## Report to Planning and Environment Committee

**Subject: Public Participation Meeting Report  
31675 Ontario Ltd (York Developments)  
3080 Bostwick Road (Site 1)**

**Public Participation Meeting on: November 12, 2018**

Figure 4: Conceptual Site Plan

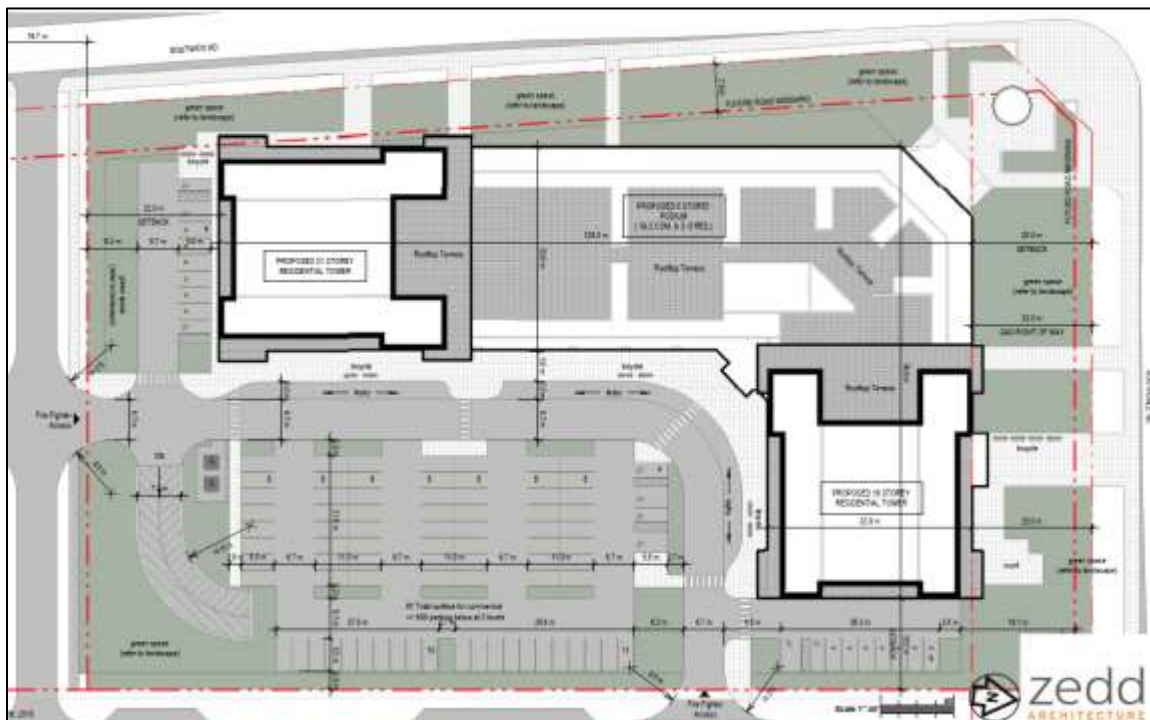
The form of development lacks certain design features such as tower setbacks which would contribute to positive design and better pedestrian environment. The over-use of the site results in towers that present sheer walls to the street with minimal relief which emphasizes the tower height and massing. The proposed built form exceeds the maximum lot coverage for the site and requires additional modification to the form or additional lands to create a better built form outcome.

The vehicular access for Street A will require modification as there will be a median proposed along Southdale Road West, and the proximity of the existing traffic lights at Bostwick Road would not facilitate an additional set of lights. Certain amendments such as compliance with the City's Access Management policies are required to the TIA, which is currently under review. Sidewalks will be required on both sides of new streets to provide for comfortable pedestrian connections.

Figure 6: Master Plan Intensities

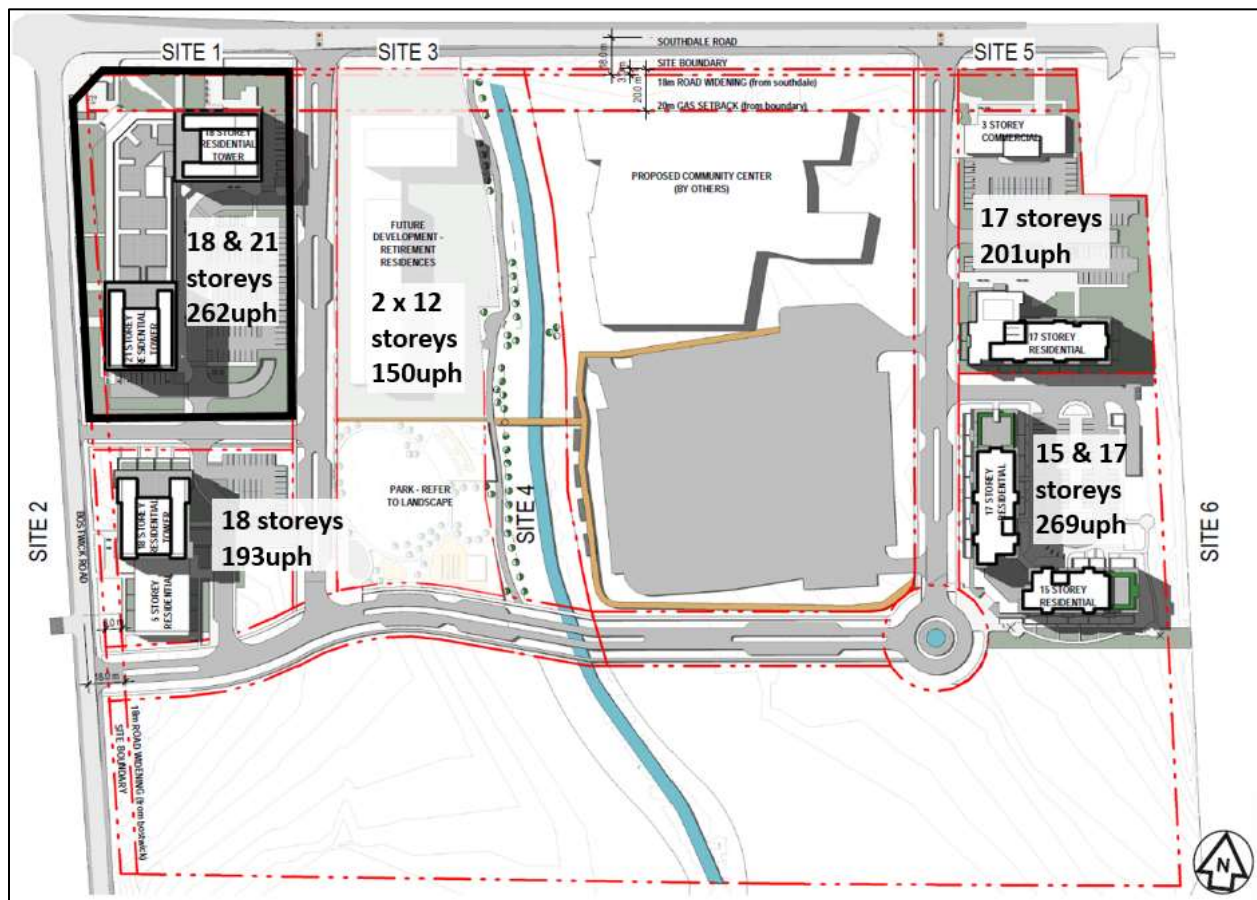
The existing zone is an Urban Reserve (UR4) Zone which is intended to protect large tracts of land from premature subdivision and development in order to provide for the future comprehensive development on those lands. Despite the application for a site specific Official Plan and Zoning By-law Amendment and consent to sever, the entire legal parcel of 3080 Bostwick Road and its relationship to Site 1 requires holistic consideration, and the site cannot be evaluated in isolation. The remainder of the lands at 3080 Bostwick Road are also proposed for various high density residential development forms through other separate Official Plan/Zoning Amendments and a plan of subdivision. There are four additional development sites proposed, with three development sites (Site 5, Block 2 & Block 6) exceeding the maximum height and density, and one development site proposing the highest level permitted (Site 3).

does not conform to the policies of the City Structure Plan and intent of The London Plan that directs the most intensive development to strategic locations to make wise planning decisions. The concentration of the high density residential units outside of a targeted growth area like the Built-Area Boundary or Primary Transit Area influences the growth patterns and demand in the Southwest Area and broader City context.

The requested mixed-use apartment is contemplated as an appropriate use for the lands, however the height of 18 and 21 storeys and density of 262 units per hectare exceeds the High Density Residential Overlay, the High Density Residential designation in SWAP and the Multi-Family, High Density Residential designation policies of the 1989 Official Plan; all of which consider development up to 12 storeys and 150 units per hectare.
